Addendum No. 1

STEAD MAIN REPLACEMENT PHASE 2

PWP No.: WA-2017-040
TMWA Project No.: 10-0001.030

December 21, 2016

SHEET NUMBER
P5
7 OF 36

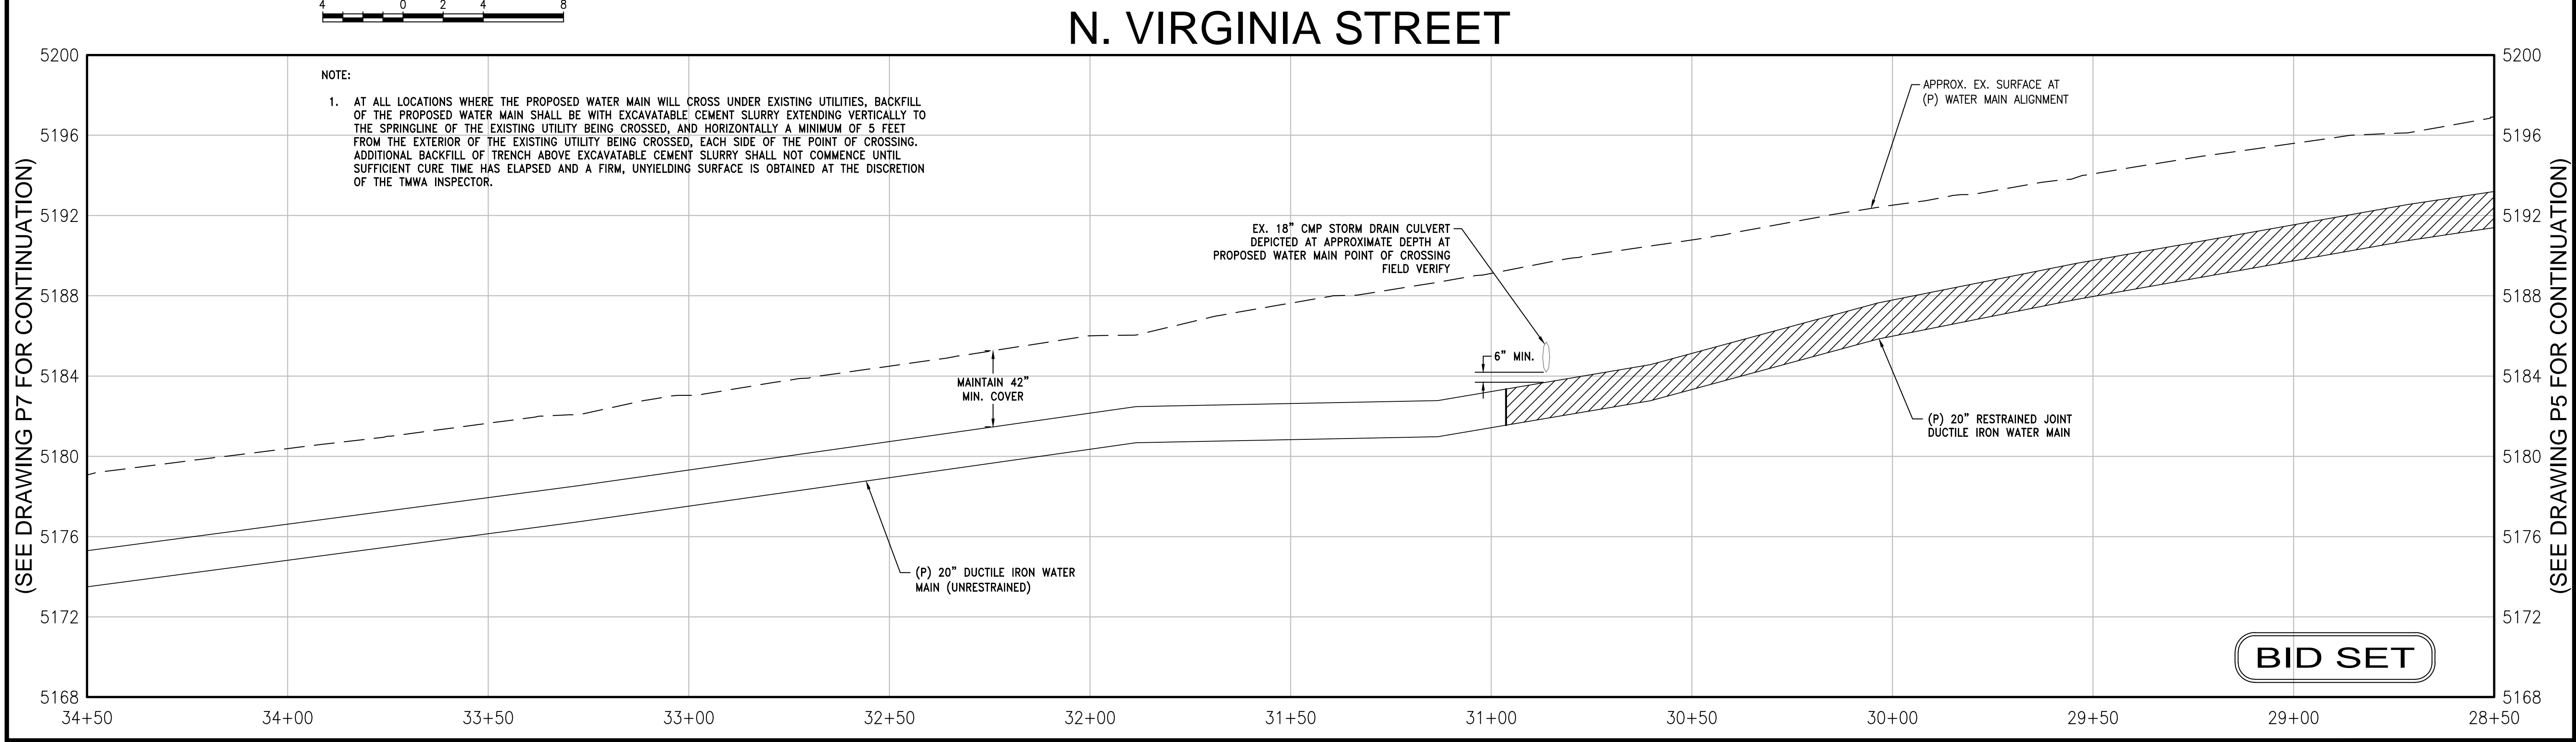
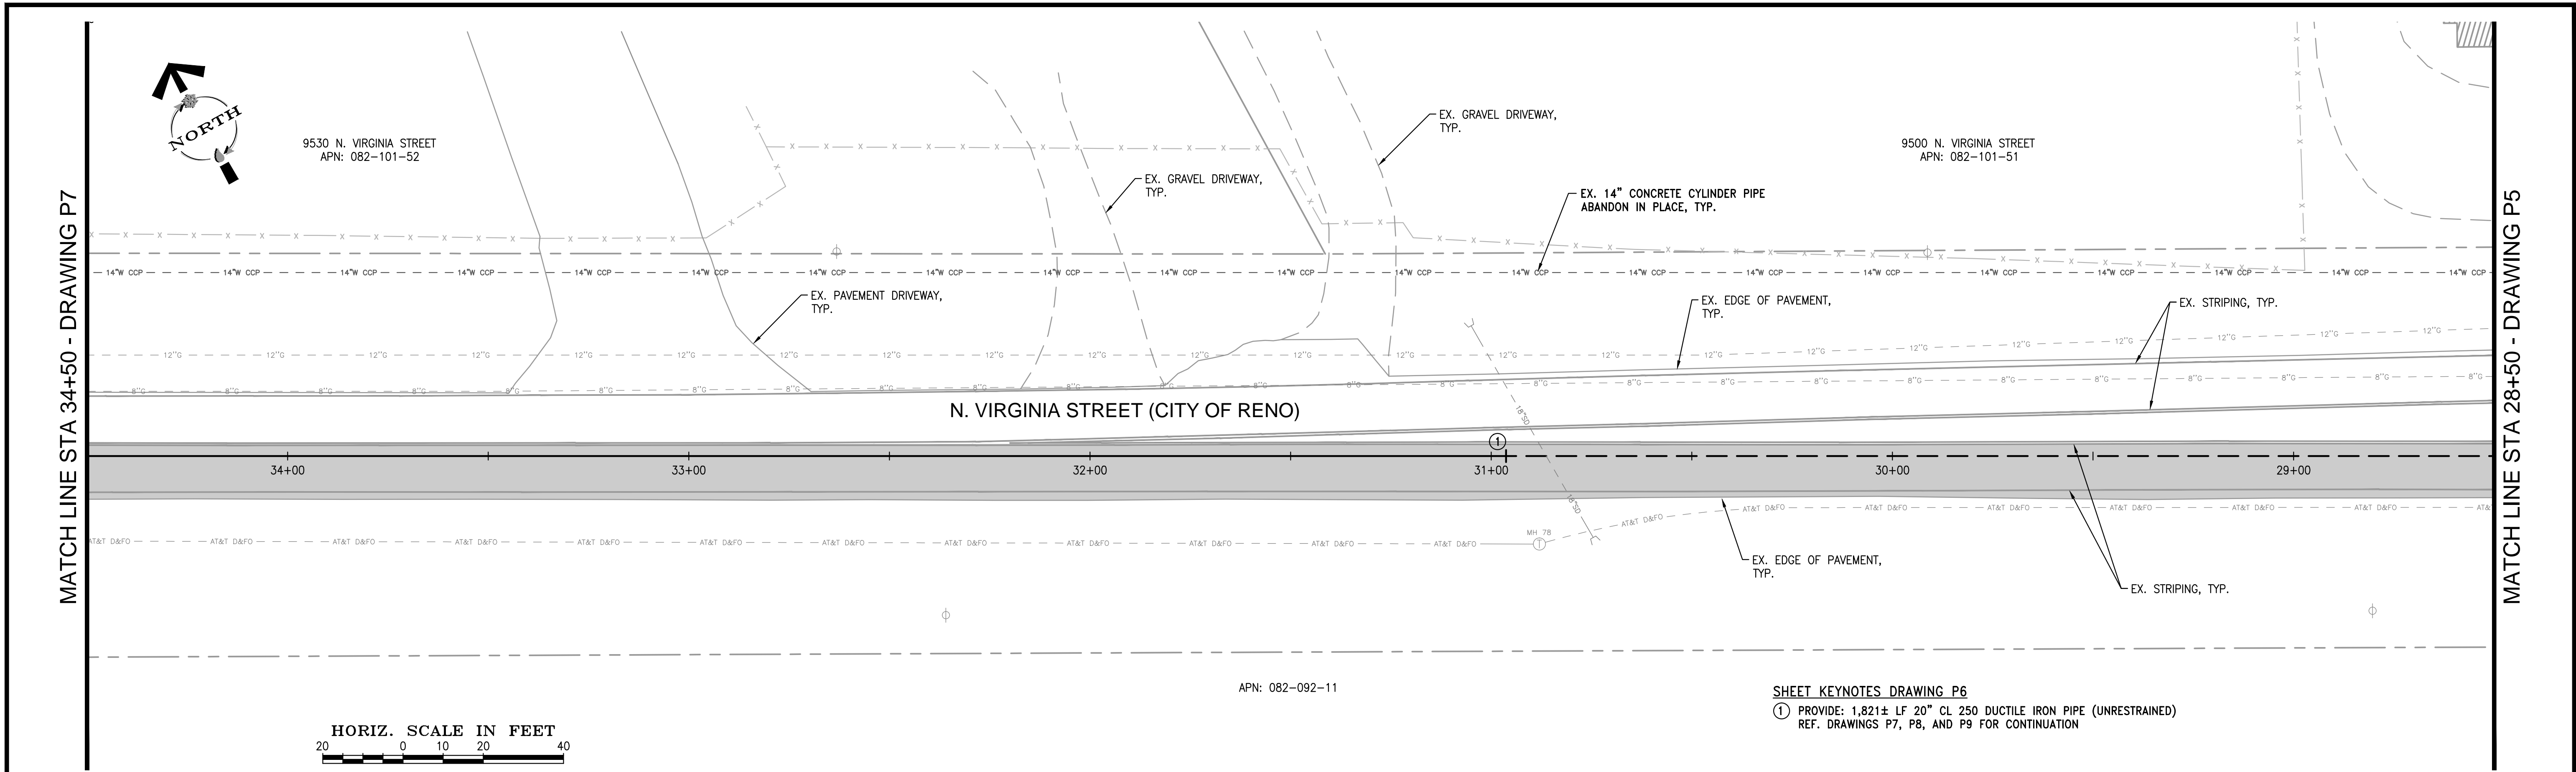
1. REPLACE the following Drawings with the attached revised version of each Drawing containing Addendum No. 1 revisions:
 - Drawing P5 (sheet 7) – revised pipeline profile to eliminate high point at STA 27+07± and added note regarding removal of existing 8-inch water main if it is in conflict with the new water main installation.
 - Drawing P6 (sheet 8) – revised pipeline profile to accommodate revision from drawing P5
 - Drawing P10 (sheet 12) – revised pipeline profile to eliminate flat slope between STA 54+10± to STA 56+40±
 - Drawing P12 (sheet 14) – revised pipeline profile to eliminate flat slope between STA 67+25± to STA 69+40±
 - Drawing P20 (sheet 22) – added Combination Air Release Valve at STA 109+25±, reference Sheet Keynote #9

SHEET NUMBER
D3
33 OF 36
12/21/2016

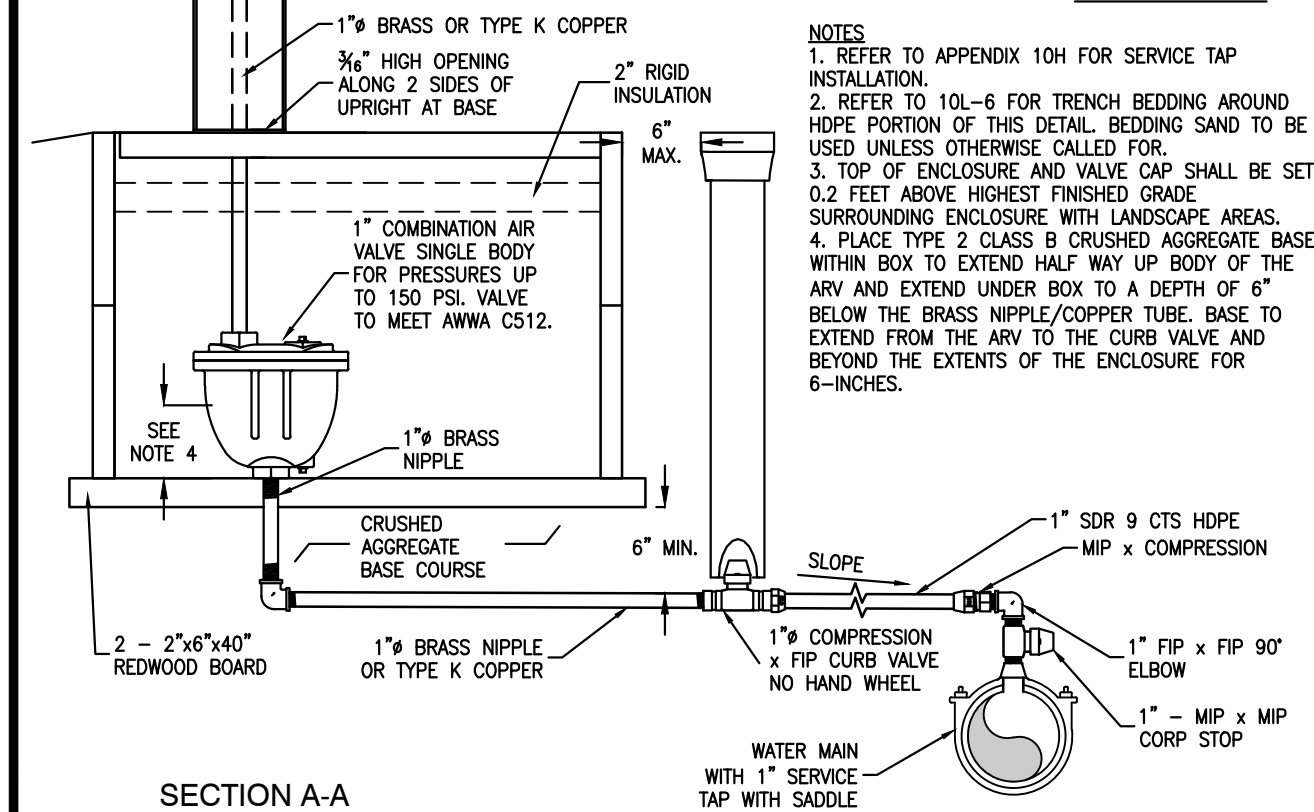
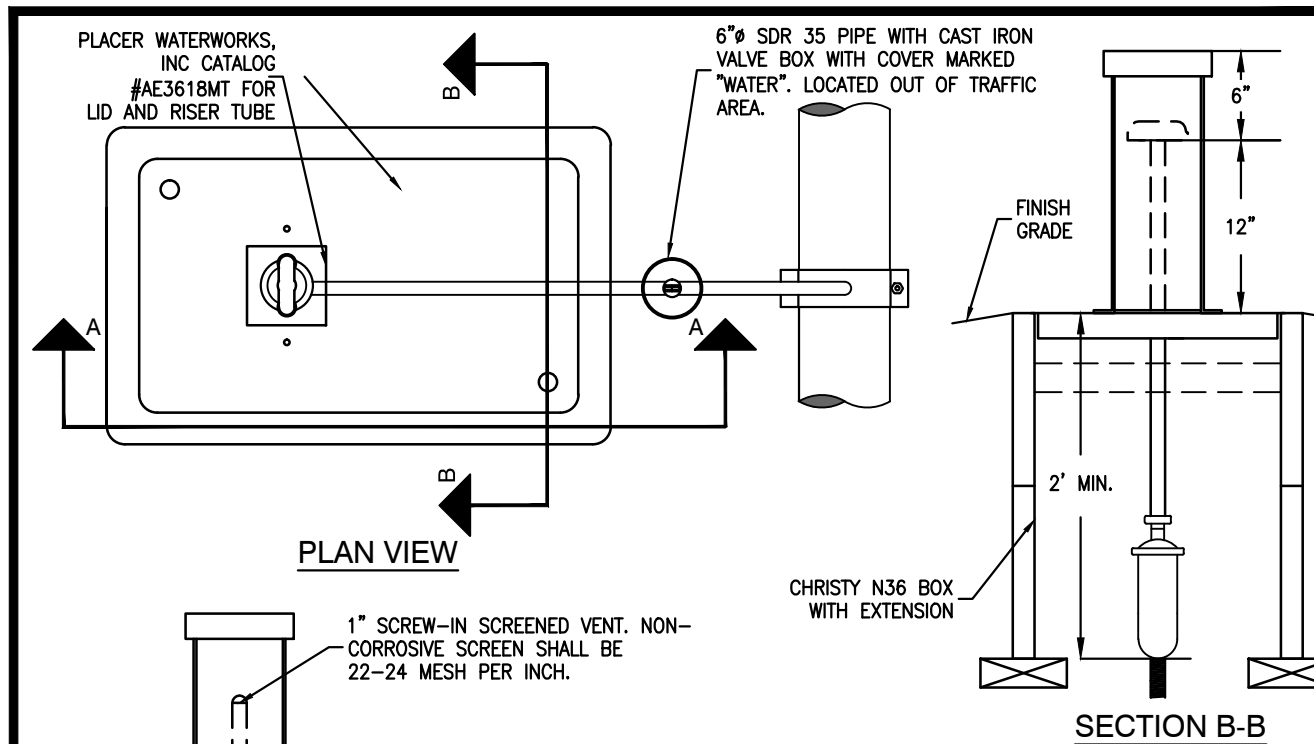
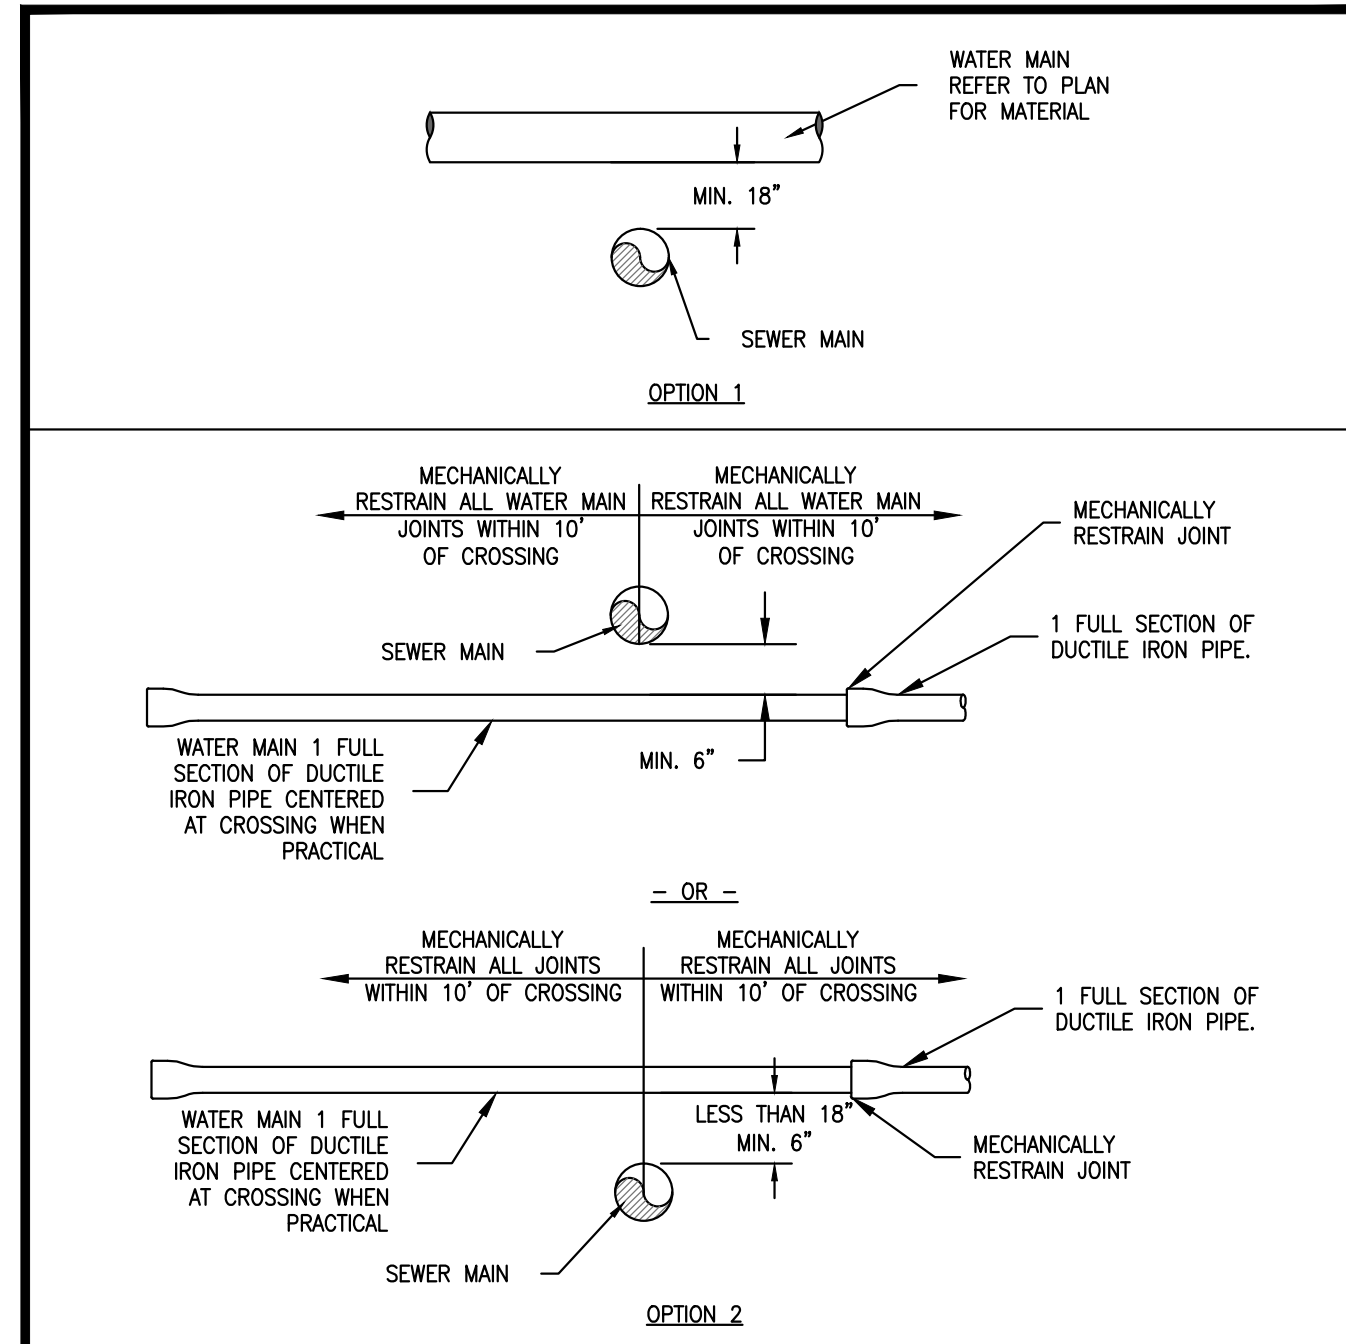
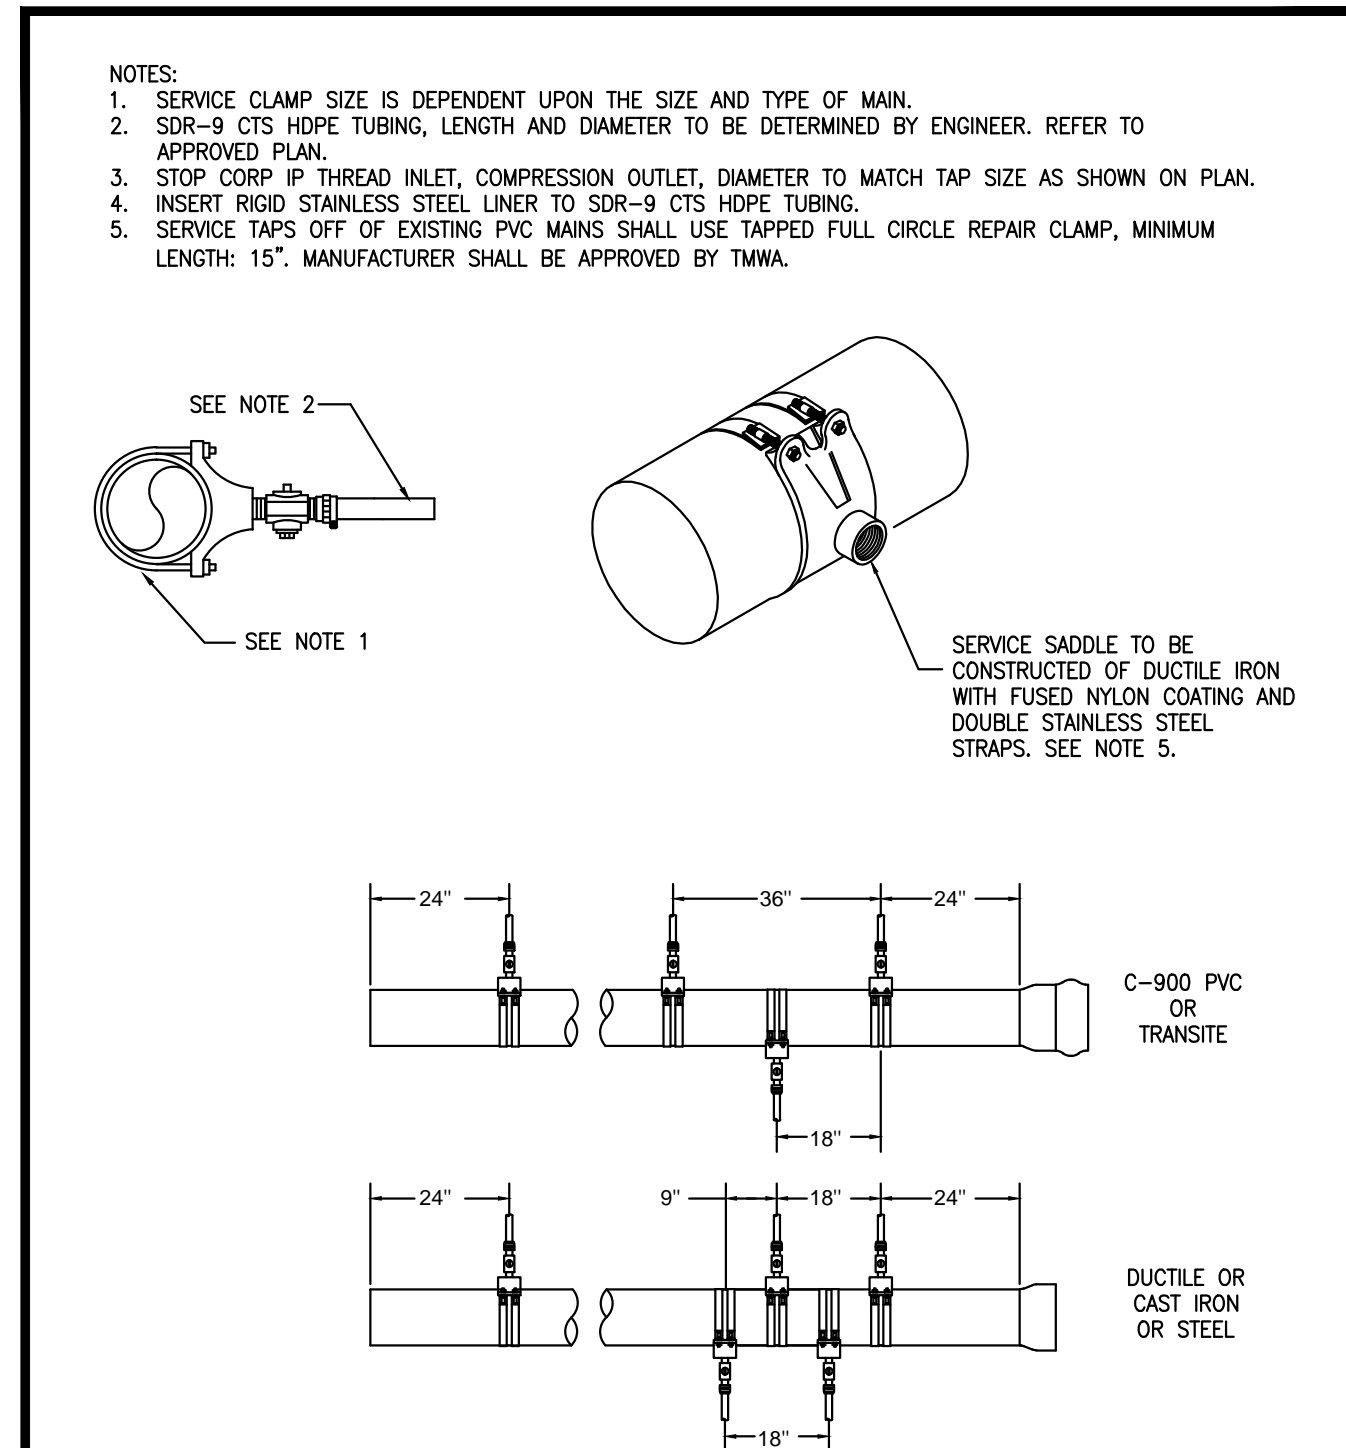
Drawing D3 (sheet 33) – added TMWA Standard Details 10L-4 and 10H-2
